FREDERICK COUNTY PLANNING COMMISSION

TITLE: Days Range Preliminary Subdivision Plan

FILE NUMBER: S-1113, APFO #12997 (AP #12995 & FRO #13723)

REQUEST: Preliminary Plan Approval

Exhibit #1: Days Range 45-Lot Subdivision Rendering

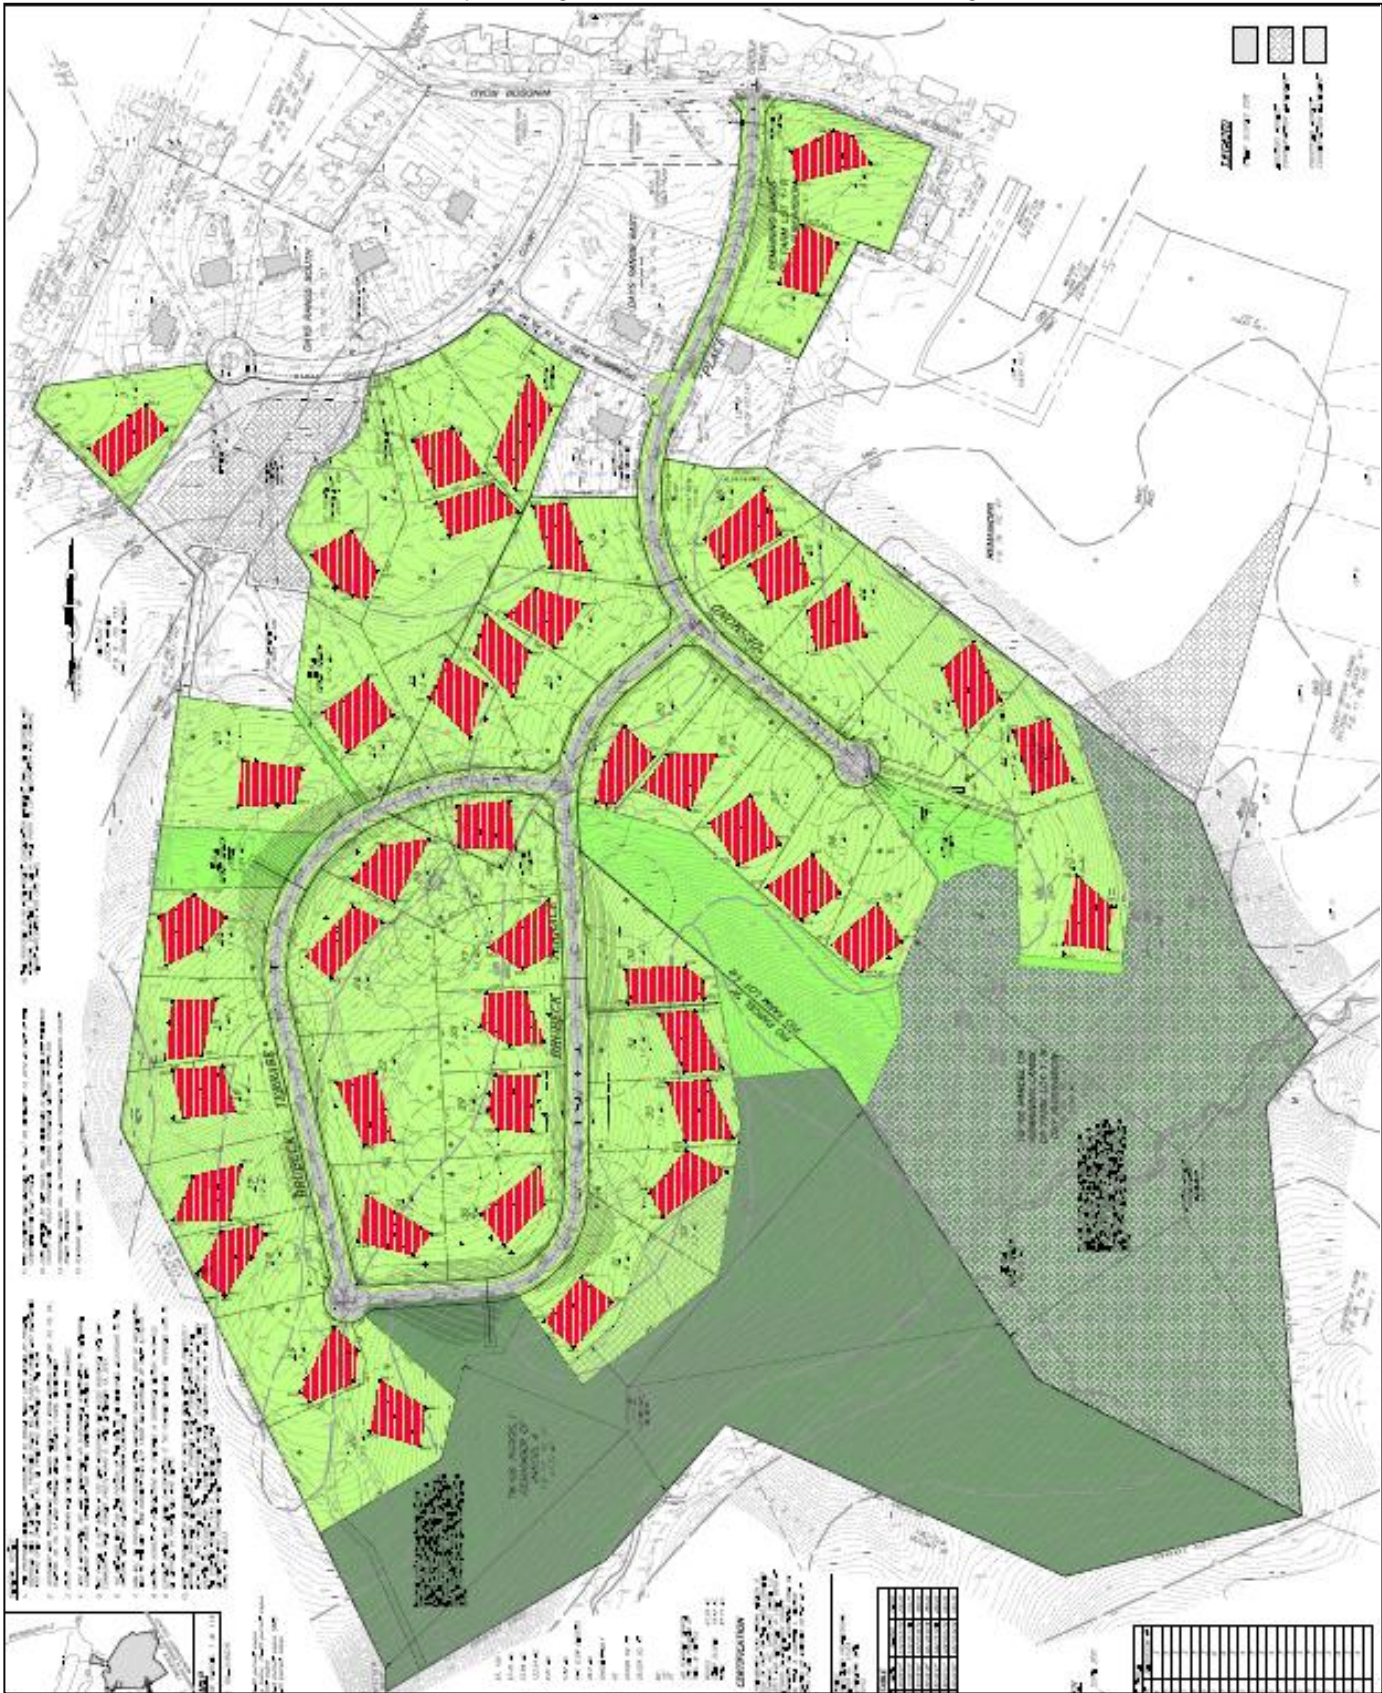
The street network and lot layout is designed to avoid stream crossings and provide increased connectivity with the existing subdivisions. A proposed street connection with the adjoining Days Range East and South subdivision, via Drummers Pass, facilitates pedestrian and vehicular connectivity. To achieve this connection, the existing Drummers Pass cul-de-sac will be converted into a perpendicular intersection with the proposed Desmond Place.

This subdivision includes proposed connections to Drummers Pass and Days Court; both roads provide access to the adjoining Days Range East and South subdivisions. There are no further connections to the south or the east due to steep grades and existing and proposed FRO easements. The property to the west is fully developed with the existing Loch Haven residential subdivision. Oriole Drive to the north within the existing Meadowbrook subdivision will be extended into the Days Range site.

The proposed circulation network is comprised of a cul-de-sac and loop system that has been designed to work within the environmental and topographic site constraints. Desmond Place, the one cul-de-sac proposed within the project, emanates from Windsor Road and serves the eastern portion of the development. This cul-de-sac is 450 feet long from the point where it adjoins Brubeck Terrace and this portion will serve 11 lots. However, Desmond Place originates at a connection with Windsor Road and is approximately 1550 feet long in total length and serves a total of 15 lots. The western portion of the project is served by the loop system of Brubeck Terrace. This roadway services the western portion of the site and the remaining lots, with the exception of Lots 3, 4, 5, 6, & 7 which gain access from the existing Days Court. The Brubeck Terrace loop system adjoins the proposed roadway network which allows for two access points to Winsor Road via Drummers Pass and the extension of Desmond Place.

Staff worked with the Applicant to achieve a looped design that takes advantage of existing road networks to create connectivity where possible. However, the extension and loop of Brubeck Terrace beyond Drummers Pass does create a dead end street system requiring Planning Commission approval.

All of the proposed lots meet the minimum 40,000 square foot (0.92 acres) lot size requirement. Lots range in size from 1.0 acres up to 2.0 acres, with an average lot size of 55,473 square feet, or 1.2 acres. The required front, rear, and side setbacks are shown on the plan and meet the requirements of the Zoning Ordinance.

- Lots 4-5, located off of Days Court. These lots will access Days Court via private drives.
- Lot 20, located at on the southern portion of Brubeck Terrace. Although the lot has access to Brubeck Terrace, the lot width is constrained by adjacent steep slopes to the east.
- Lots 39-41, located at the terminus of Desmond Place. Lot 39 will access Desmond Place via a private driveway. Lots 40 and 41 will access Desmond Place via a use-in-common driveway to be shared and maintained by the lot owners.
- A note will be added to the final subdivision plat, indicating that the property owners will be aware of their shared access and maintenance obligations.

In order for Planning Commission to approve these panhandle lots, it must find that the lots meet “excellence of design based on the spatial relationship of the panhandle lot to other lots and the public road.” The Applicant has submitted a panhandle modification request for the six panhandle lots, see Exhibit #3. Staff supports this panhandle modification request due to natural features constraints and suitable septic locations.

1. The Applicant shall comply with all Staff and agency comments through the completion of the plan.
2. Planning Commission approval of the six panhandle lots and the proposed street system in accordance with subdivision regulations.

3. The purchasers of the panhandle lots are to be notified of the responsibilities of maintaining the panhandle area and common driveways.
4. The Preliminary/Final FRO plan must be approved prior to final Preliminary Subdivision plan approval. FRO mitigation must be provided prior to applying for grading permits or building permits, whichever is applied for first.
